Serial: NPD-NRC-2015-038  
September 1, 2015

**LEVY NUCLEAR PLANT, UNITS 1 AND 2  
DOCKET NOS. 52-029 AND 52-030  
SUBMITTAL OF EXEMPTION REQUEST AND DESIGN CHANGE DESCRIPTION FOR  
DEPARTURE FROM AP1000 DCD REVISION 19 TO ADDRESS COMPLIANCE WITH  
IEEE 603-1991**

Request For Exemption Regarding  
IEEE 603-1991 Compliance

Figure 7.2-1 (Sheet 3 of 21)

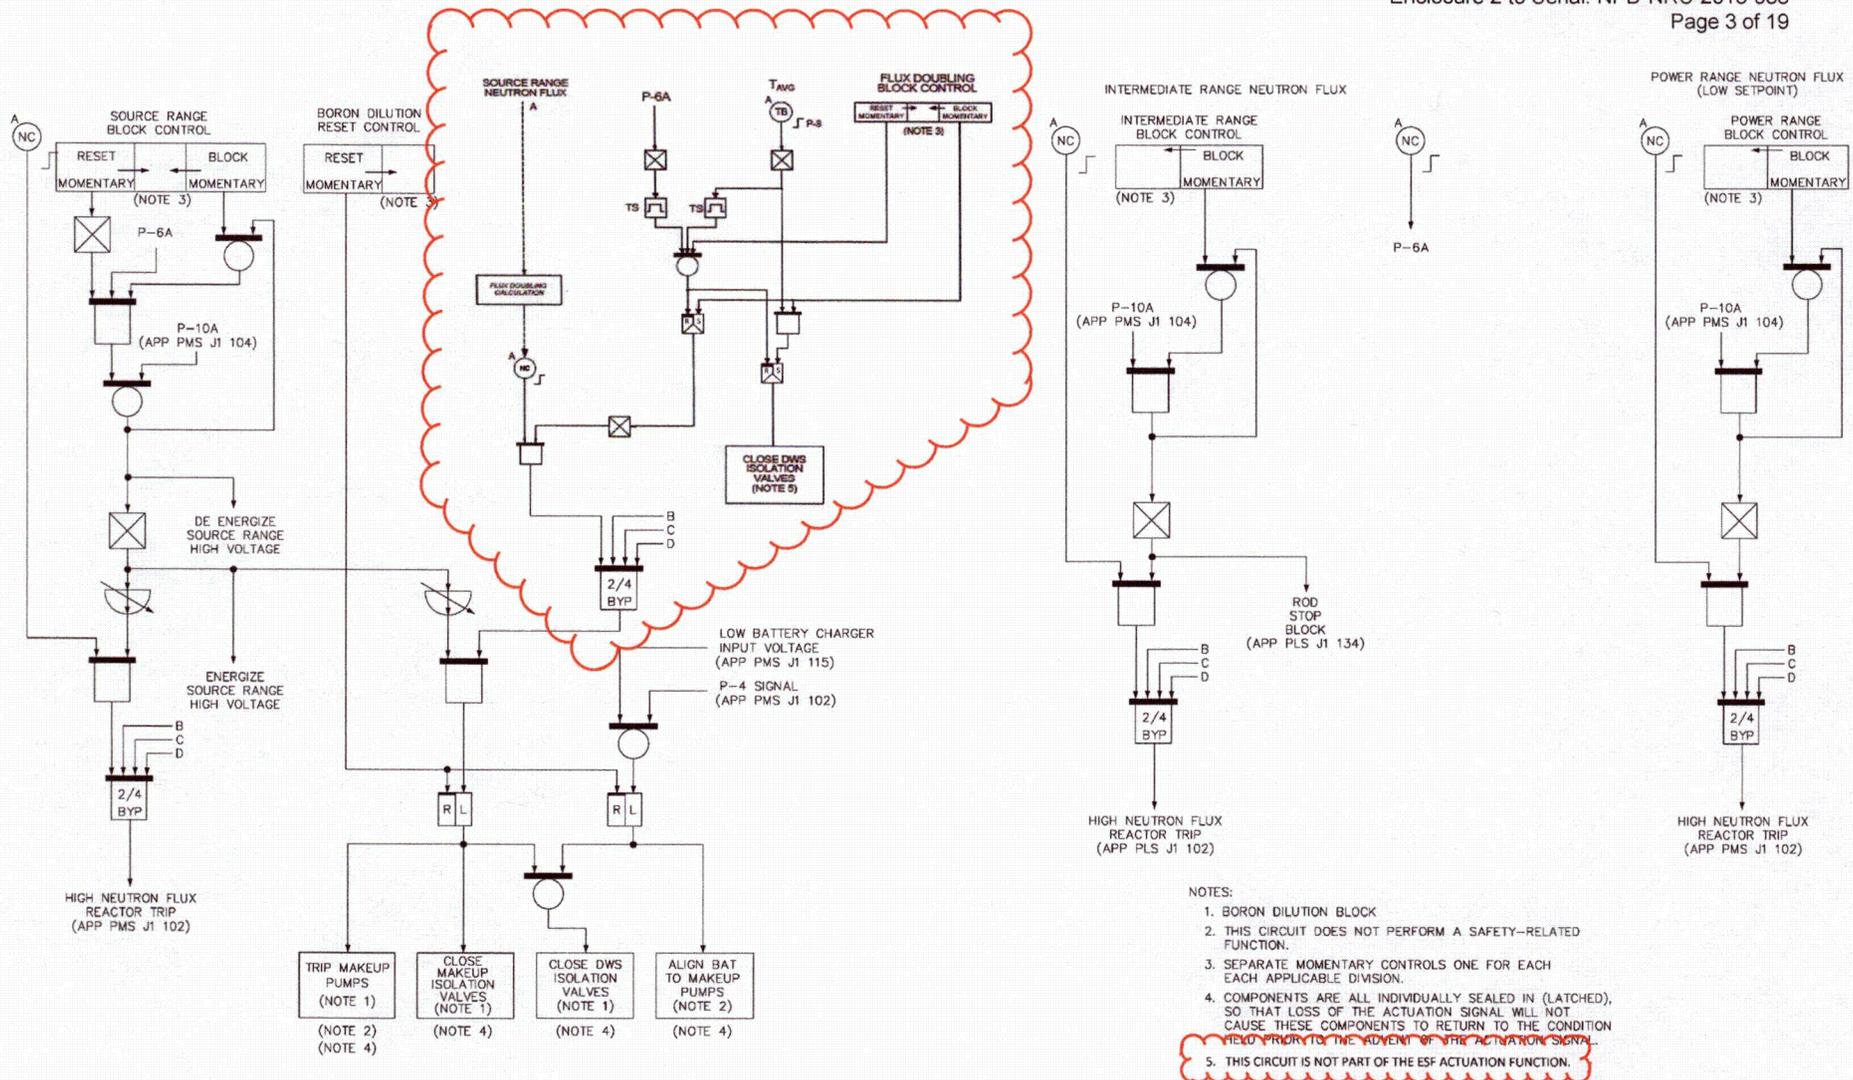
Operating bypasses are included in the AP1000 design to allow functions to be blocked so normal plant operations can occur without unnecessary actuation of safety systems. All of the protective actions initiated by the Protection and Safety Monitoring System (PMS) comply with the criteria of IEEE 603 Clause 6.6 with the exception of the PMS arrangements for blocking the source range neutron flux doubling logic input to Boron Dilution Block shown on DCD Figure 7.2-1 (Sheet 3 of 21).

- Figure 7.2-1 (Sheet 3 of 21); Add logic for condition when source range flux doubling signal may be manually blocked and automatically reset.
- Section 7.3.1.2.14, Boron Dilution Block; Revise discussion of conditions when the source range flux doubling signal may be manually blocked and when it is reinstated.

- 1) Add a new permissive, P-8, to permit blocking the flux doubling logic during reactor startup. (P-8 provides the logical permissive input to the PMS. P-8 is set to 551°F Reactor Coolant System (RCS) temperature, the minimum temperature for criticality.)

- 2) Add logic that will cause the PMS to force CVS valves 136A and 136B closed if the flux doubling logic is blocked when reactor temperature is less than P-8. (This ensures a permissible condition exists before flux doubling is bypassed below P-8, which is one option from IEEE 603 - 1991, the other being to perform the appropriate safety functions.)

- 3) When RCS temperature is below P-8, reset the flux doubling logic if CVS valves 136A and 136B are opened.
- 4) Add an additional reset of source range flux doubling logic when RCS temperature falls below P-8. Existing PMS design resets flux doubling logic when neutron flux decreases below P-6.

Figure 7.2-201 (Sheet 3 of 21)

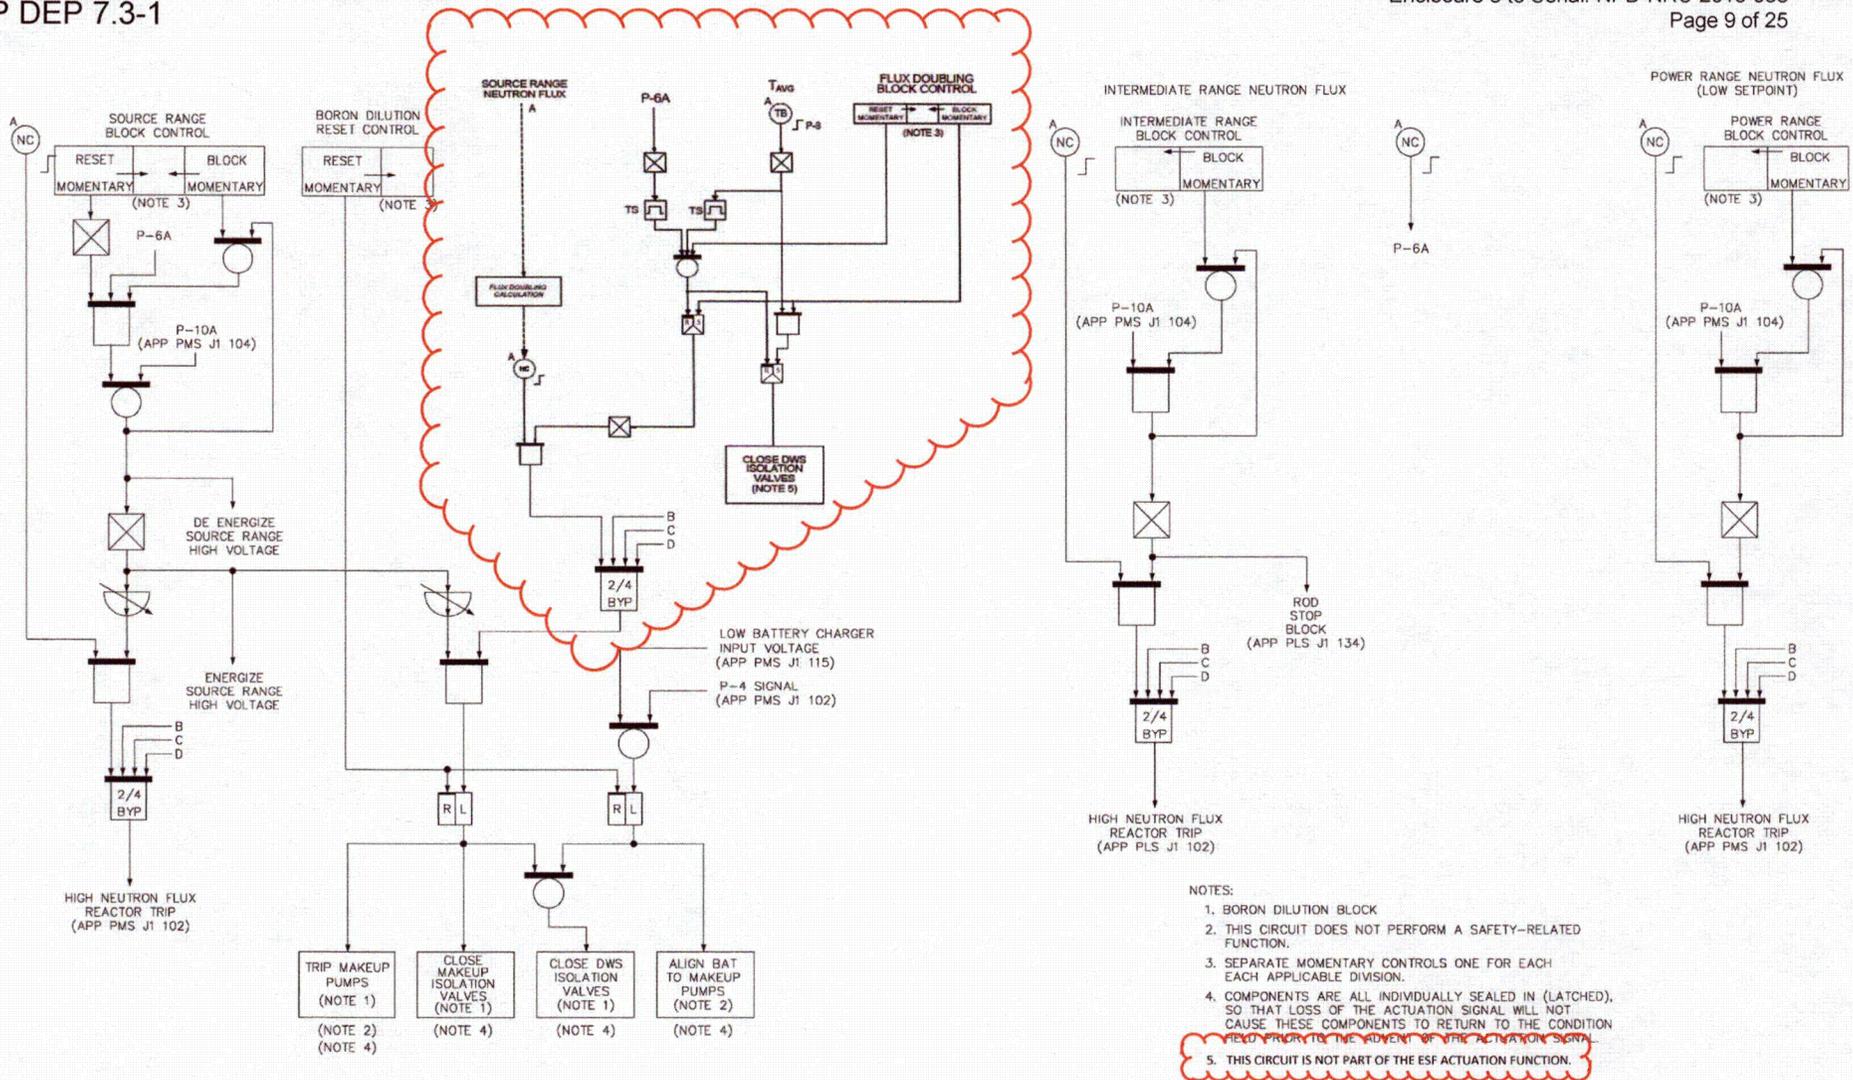
1. COLA Part 2, Figure 7.2-201 will be revised to show the P-8 permissive to allow blocking of Flux Doubling function
2. COLA Part 2, Subsection 7.3.1.2.14 will be revised to state "This source range flux doubling signal may be manually blocked to permit plant startup and normal power operation when reactor coolant average temperature is above the P-8 setpoint. It is automatically reinstated when reactor power is decreased below the P-6 power level during shutdown or reactor coolant average temperature decreases below the P-8 setpoint. The Flux Doubling function can also be manually blocked during shutdown conditions when
